**ADDENDUM NO. 3**  
**05/06/2024**

**PROJECT: CITY OF IDALOU**  
**ELEVATED STORAGE TANK IMPROVEMENTS**

**BID DATE: MAY 9, 2024**

ELECTRICAL GENERAL NOTES AND DETAILS

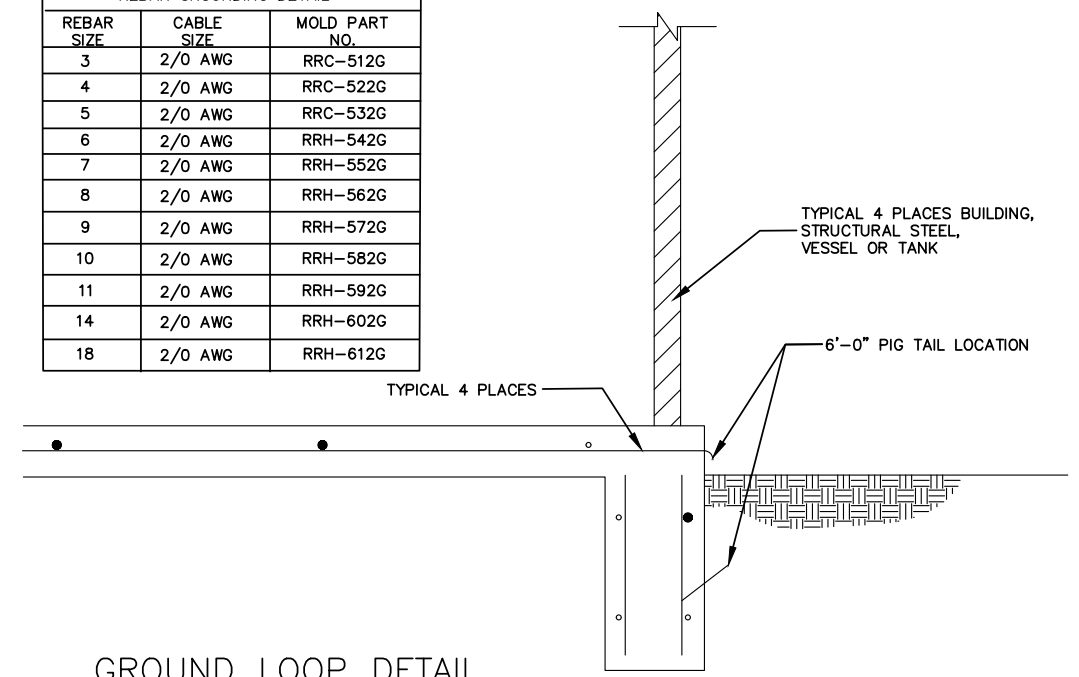
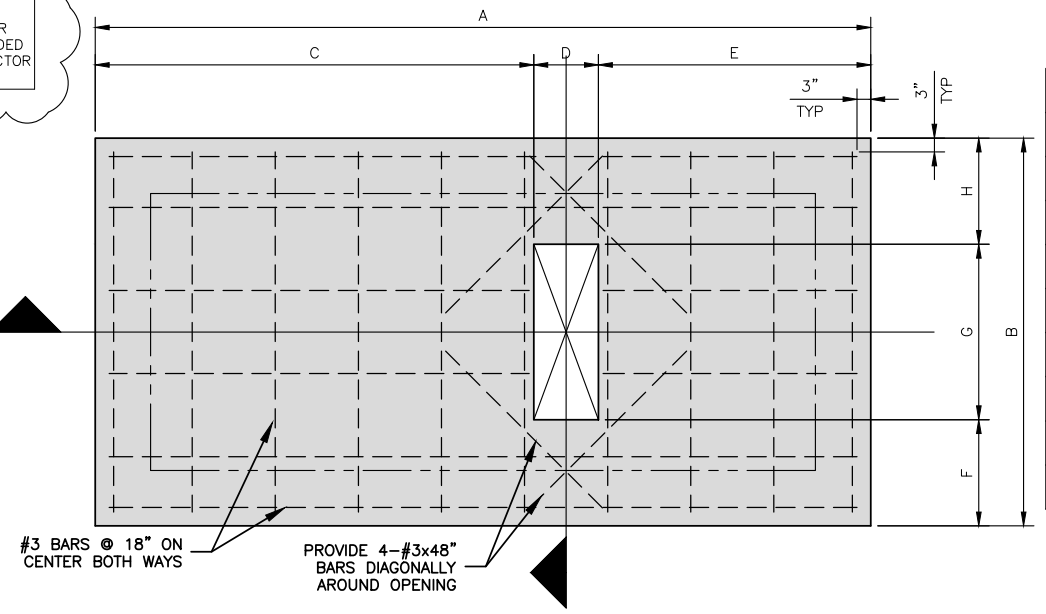
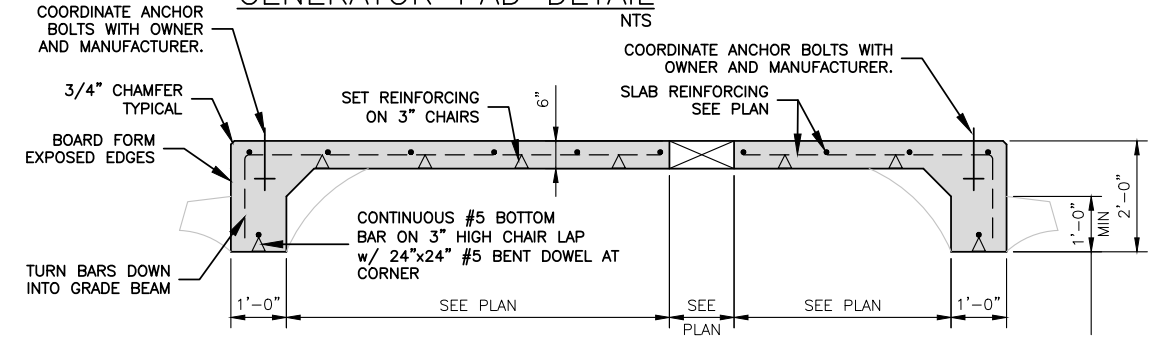
- a) Sheet E-1 – Electrical General Notes and Details– This sheet has been added to provide additional details on the elevated tank lighting equipment.
